RE: ST FRANCIS COLLEGE STAGE 1 - LANDSCAPING (SSD-10365)

City Plan Strategy & Development P/L (City Plan) acts on behalf of the proponent of the abovementioned application. This correspondence responds to the NSW Department of Planning, Industry & Environment's (DPIE) request for additional information in relation to the abovementioned application, dated 11 August 2020. DPIE's request also sought a response to submissions received from the public as well as other government agencies during the application's exhibition period.

Figure 1: Extract of amended landscape plan with 3 pedestrian entries circled blue (Source: Arcadia/City Plan)

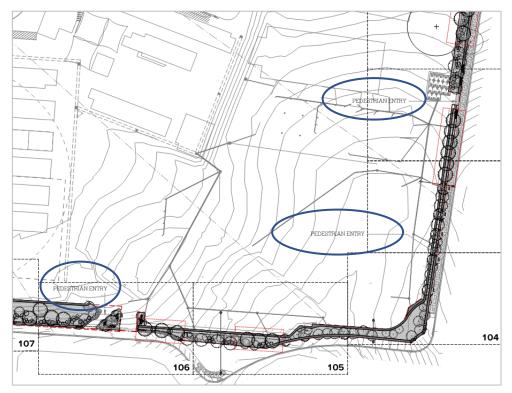
3. PEDESTRIAN ENTRIES

The pedestrian entries were erroneously omitted from the proposed landscape plan. An amended plan accompanies this correspondence which includes three (3) pedestrian entry points, consistent with the original Concept Approval SSD 8832. For information, an extract of the amended landscape plan showing the pedestrian entry points circled blue, is provided on the following page.
